REVISION TRANSMITTAL

This sheet transmits Revision 1 to SL560XL-34-27, which:

NAVIGATION - GPS-4000S GLOBAL POSITIONING SYSTEM SOFTWARE UPDATE

**Service Information Letter GPS-4X00()-19-3
REVISION NO. 2**

Map
Figure 1

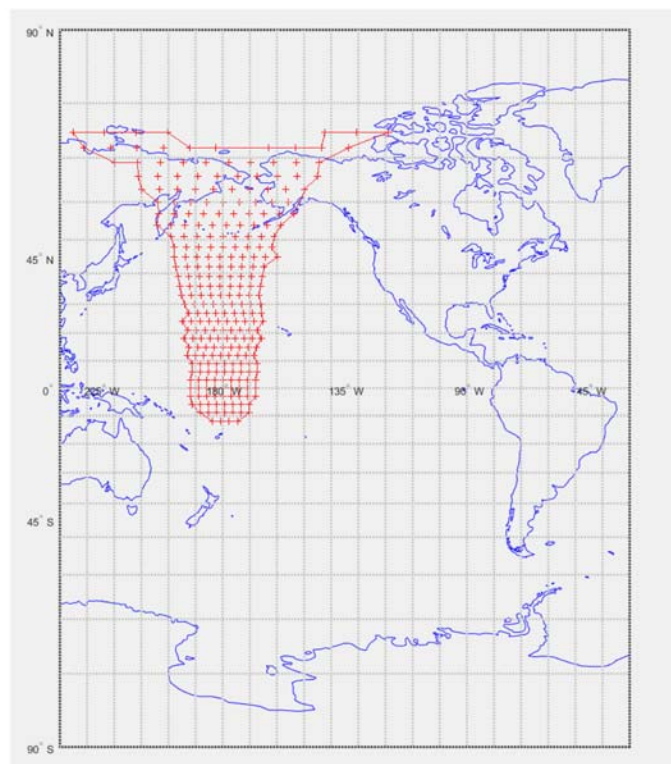
- (1) The Root Cause has been identified as an improper implementation in the computation of the longitude at which the GPS signal penetrates the ionosphere when the satellite is located across 180 degrees W Longitude.
- (2) The affected region is limited to the area within the solid red line boundary indicated in the attached map. The region extends 20 degrees on either side of 180 degrees W Longitude and extends from the Northern Hemisphere to 10 degrees Latitude in the Southern Hemisphere. Refer to Figure 1.

- (1) A software update that corrects this issue is targeted to be available in Q1 2020.
- (2) Until that software update is available, operational limitations will need to be applied. The operational limits are:
 - (a) Do not use the GPS-4000S, CPN 822-2189-100, to perform LPV approaches at airports in Alaska listed below. There are no airports outside of Alaska that are in the affected region that support LPV approaches at the time of this SIL publication. LPV-equipped airports will be monitored on every database update and if additional LPV-equipped airports are identified, this SIL will be updated.
 - (b) Do not perform operations that require an accuracy better than RNP 0.3 NM (For example, 0.1, 0.11, 0.15, etc.) in the region identified in the above map (+/- 20 degrees of 180 degrees W Longitude) or at the airports in Alaska listed below.

- (c) Other GPS-based approach types that require a position accuracy greater than or equal to RNP 0.3 NM (For example, 0.3, 1, 2, 4, 10, etc.) can be flown (i.e. Lateral Navigation (LNAV) / Vertical Navigation (VNAV)).
